PROPOSED RAMP  
 LAYOUT & DETAILS.

**PROPOSED  
 MODIFICATION  
 FOR TOILET FOR  
 HANDICAPPED.**

**FINAL PROPOSAL**

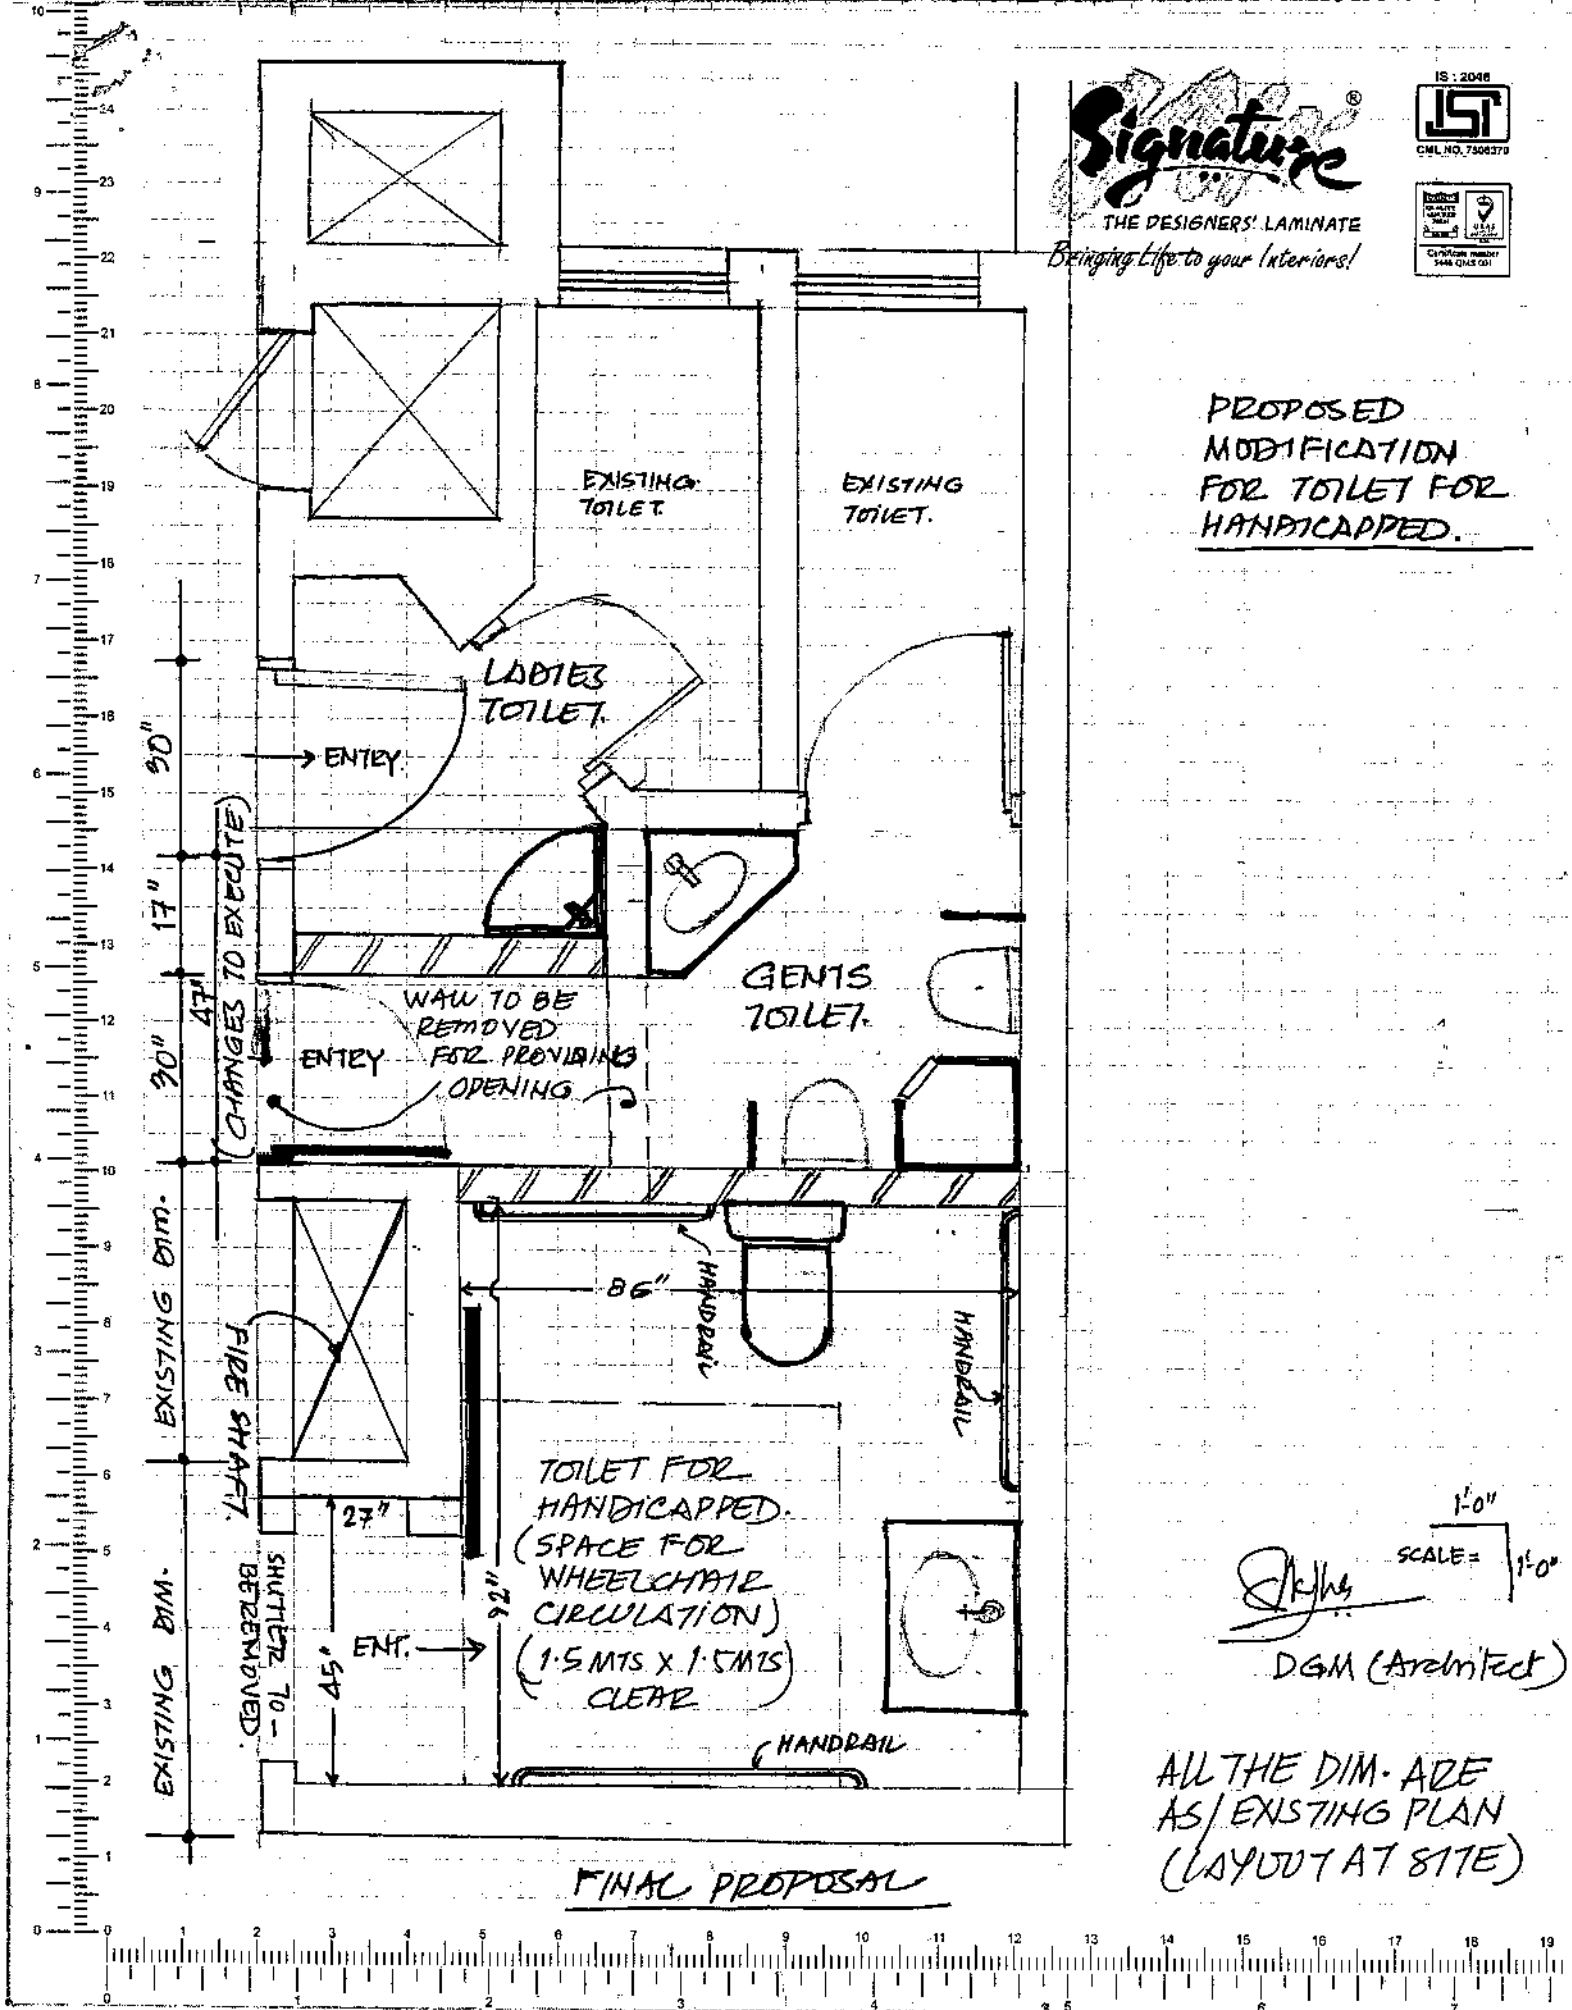
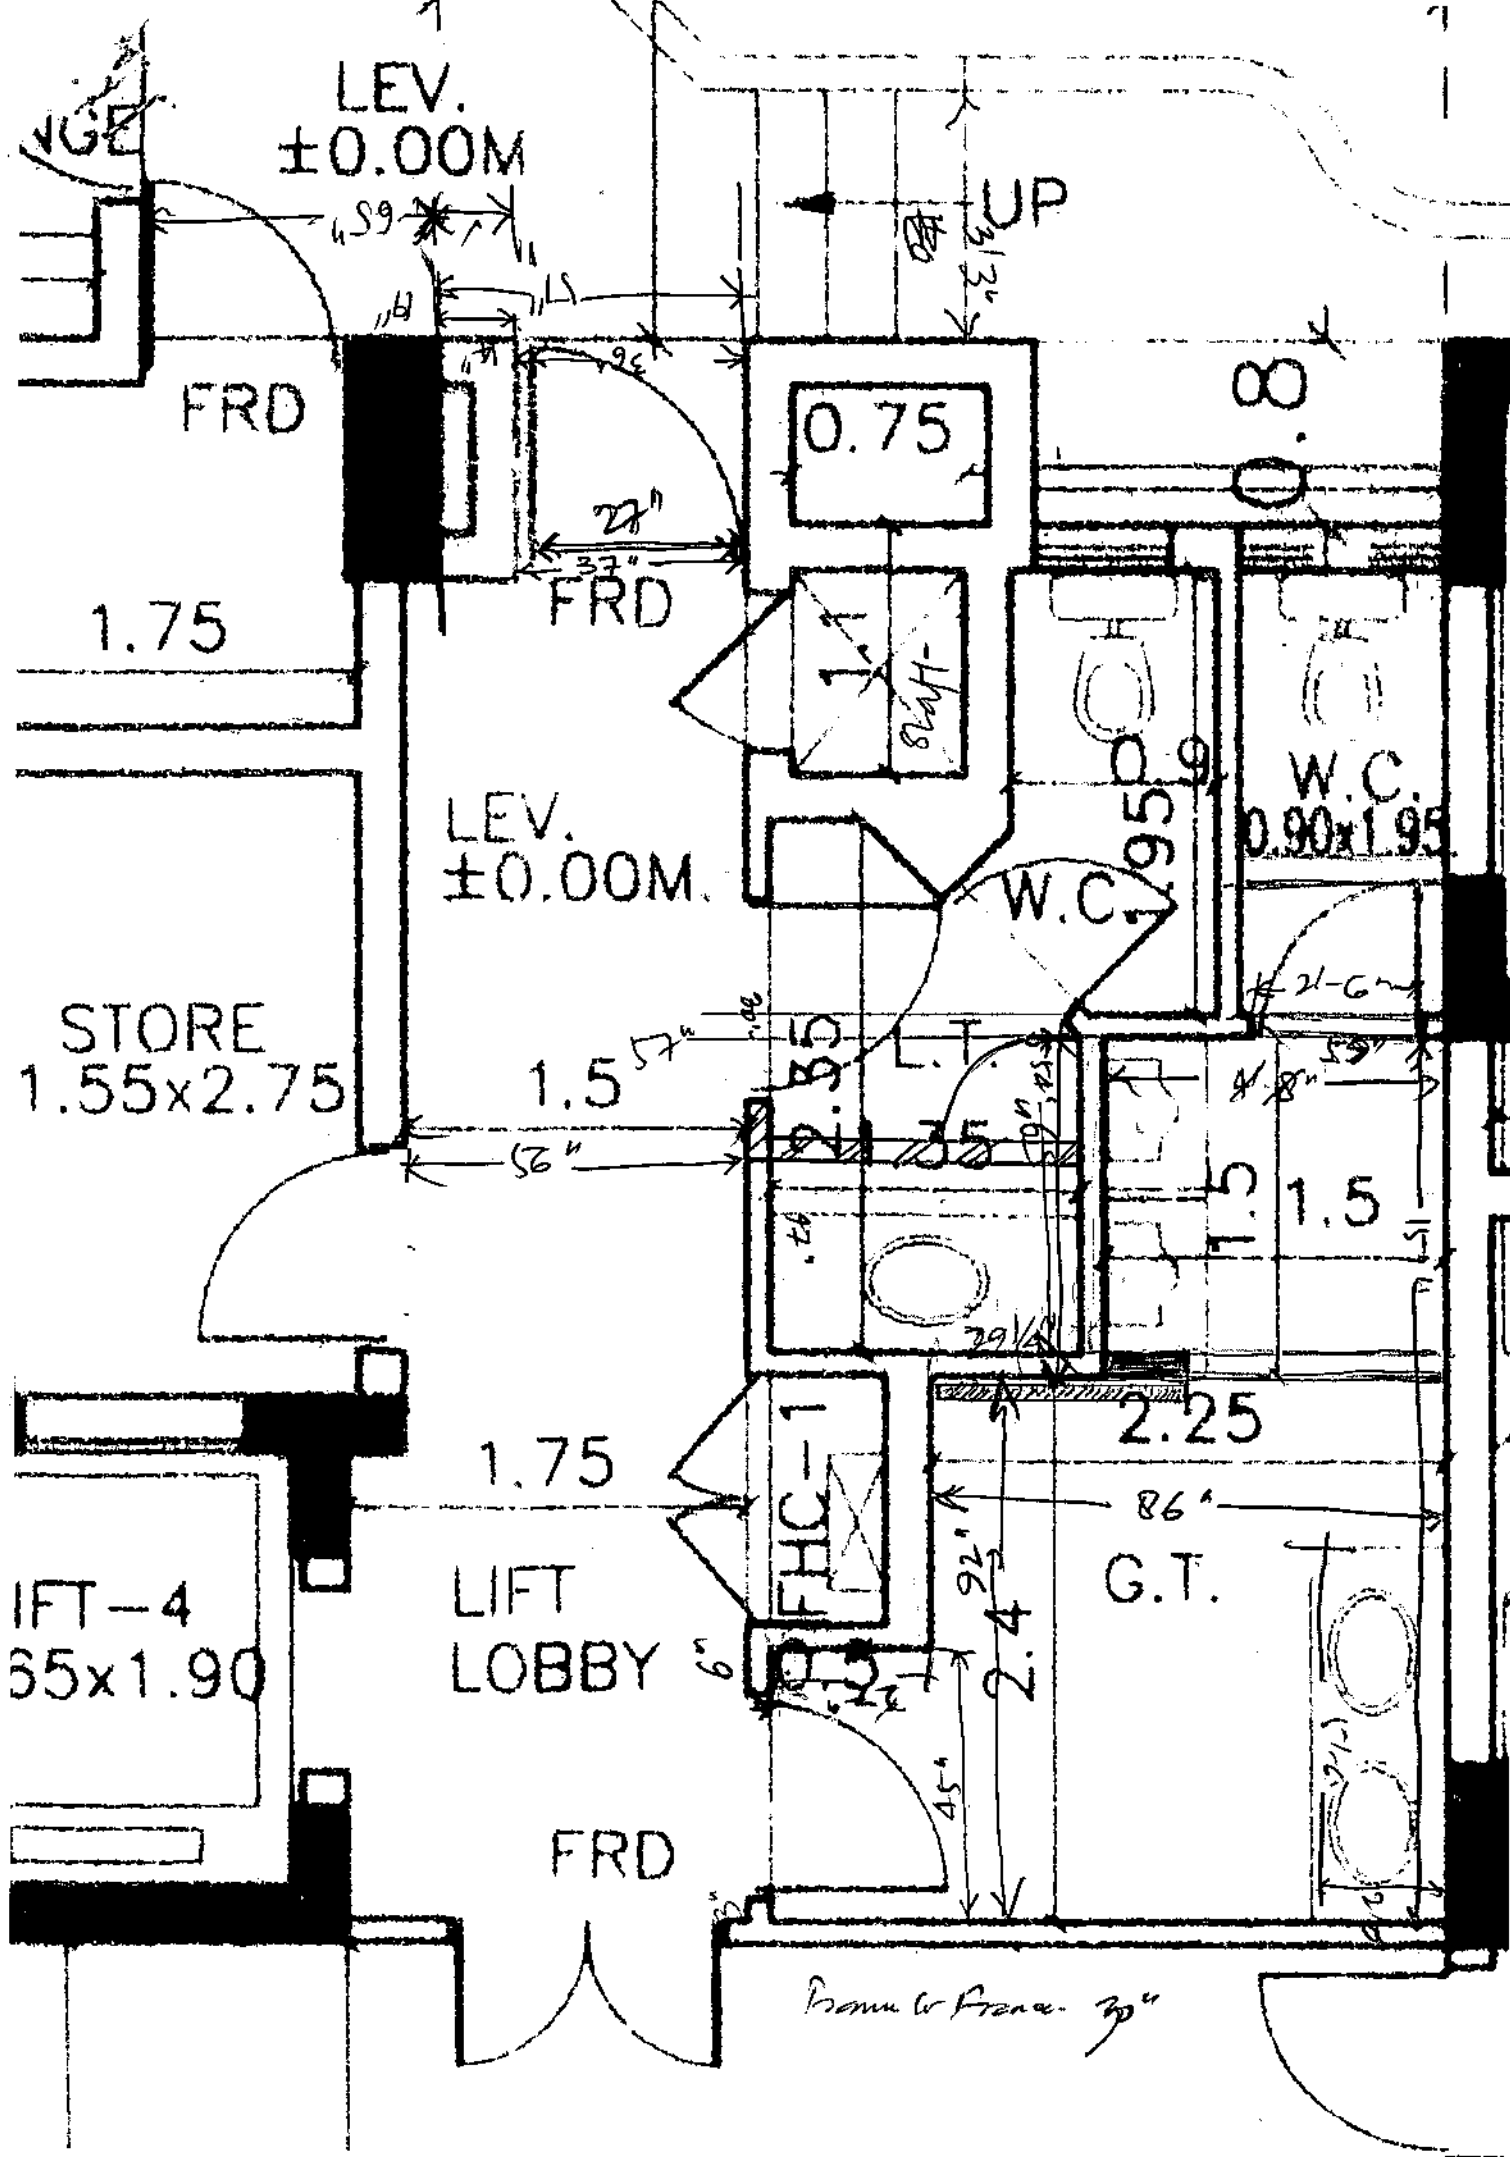
ALL THE DIM. ARE  
 AS EXISTING PLAN  
 (LAYOUT AT SITE)
